Access Compliance Report

Public Rights-of-Way

(Curb Ramps)

Intersection ID: 44915	Main Street: OAKBURN_DR	Cross Street: BERRYBROOK_LN	Location: S
ADA ID: 362E356879EA	Ramp Type: PerpDiag	Initial Pass/Fail: Fail	Overall Compliance: No
		Severity Score: 10

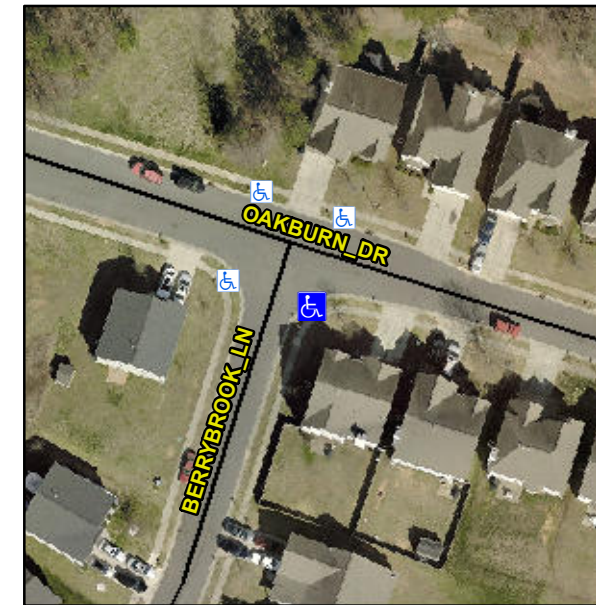
Not Found, R304.5.1, R304.5.3

Compliance	Description	Data	Compliance	Description	Data
N/A	Ramp Length (in)	48.0	Yes	Ramp Slope (%)	5.6
No	Ramp Width (in)	47.0	No	Ramp XSlope (%)	4.7
N/A	Flare Type LT	N/A	N/A	Flare Type RT	N/A
N/A	Flare Slope LT (%)	N/A	N/A	Flare Slope RT (%)	N/A
N/A	Flare Traversable LT?	N/A	N/A	Flare Traversable RT?	N/A
N/A	Landing Length (in)	N/A	N/A	DWS Provided?	N/A
N/A	Landing Width (in)	N/A	N/A	DWS Contrast?	N/A
N/A	Landing Slope (%)	N/A	N/A	DWS Length (in)	N/A
N/A	Landing X Slope (%)	N/A	N/A	DWS Full Width?	N/A
N/A	Landing Curb? (Y/N)	N/A	N/A	DWS Offset (in)	N/A
N/A	Shared Landing?	N/A			
N/A	Gutter Ponding?	N/A	N/A	Gutter Slope (%)	N/A
N/A	Gutter Lip Ht (in)	N/A	N/A	Gutter X Slope (%)	N/A
N/A	Painted X Walk1?	No	N/A	Painted X Walk2?	No
	X Walk 1 Direction	To NE		X Walk 2 Direction	To NW
N/A	X Walk 1 Width (in)	N/A	N/A	X Walk 2 Width (in)	N/A
	X Walk 1 Slope (%)	5.6		X Walk 2 Slope (%)	3.3
	X Walk 1 X Slope (%)	0.3		X Walk 2 X Slope (%)	4.4

Remove & Replace Curb Ramp With Two New Directional Ramps or Equivalent.
